ADDENDUM NO2, EA-2

JEFFERSON COUNTY
LAW ENFORCEMENT CENTER
JEFFERSON, WISCONSIN

FIRST FLOOR PLAN
COURTHOUSE
1/8"=1'-0"
LIGHTING

6-11-90
E-3

A G2.1 PARTIAL FIRST FLOOR PLAN
1/8"= 1'-0"

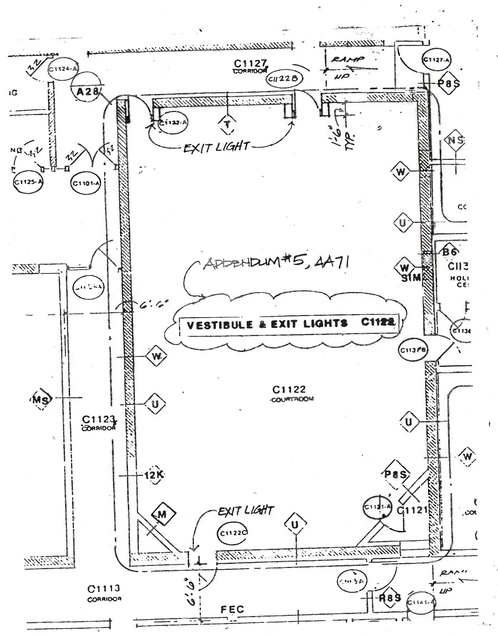
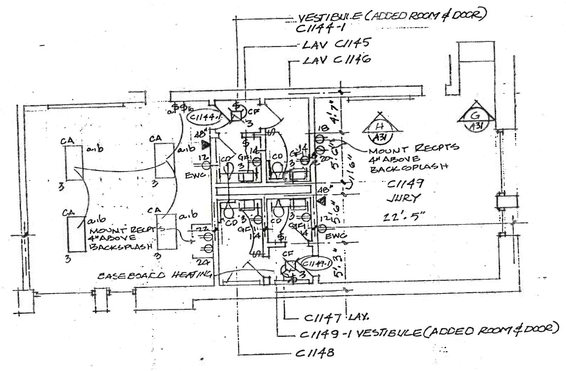
1. C1124 - See Sheet ER-2 for new lighting layout.
2. C1125 - See Sheet ER-2 for new lighting layout.
3. C1133 - See Sheet ER-2 for new lighting layout.

4. C1134 - See Sheet ER-2 for new lighting layout.
5. C1137 - Delete 2 'LA' fixtures. Install 2 'CB' fixtures.
6. C1110 - Delete 5 'CB' fixtures. Install 4 'CG' fixtures.

7. C1127 - Provide 4 'CE' fixtures in corridor C1127 circuit to existing panel.
8. C1114 - Delete 3 'CA' fixtures, 1 from each 2 fixture row.
9. C1117 and C1118 - See Sheet ER-4 for new lighting layout.

10. C1151-1 - See Sheet ER-2 for new lighting layout.
11. Add two (2) 'CL' fixtures in Room C1129 4' 0" off East wall. One (1) fixture 4' 0" off North wall to center and one (1) fixture 6' 0" South to center. Fixture to be flange type.

12. Add exit light at stair C1129-1 in Room C1129. Add exit light at exit door stair C1129-1.
13. Add cabinet unit heater in Room C1129-1 at exit door. See HVAC Drawings for exact location. CUH to be same size as motor #51. Circuit to panel 'CB'.

14. All new exit lights in Courthouse to be circuited to existing exit light panel.
15. Add exit light in Room C1101 at door to Room C1127.

Exit lights: north side of door C1113-B, west side of doors C1122-A and C1122-B; east side of door C1122-C; east side of doors C1142-A and C1143-A; and west side of door C1151-A
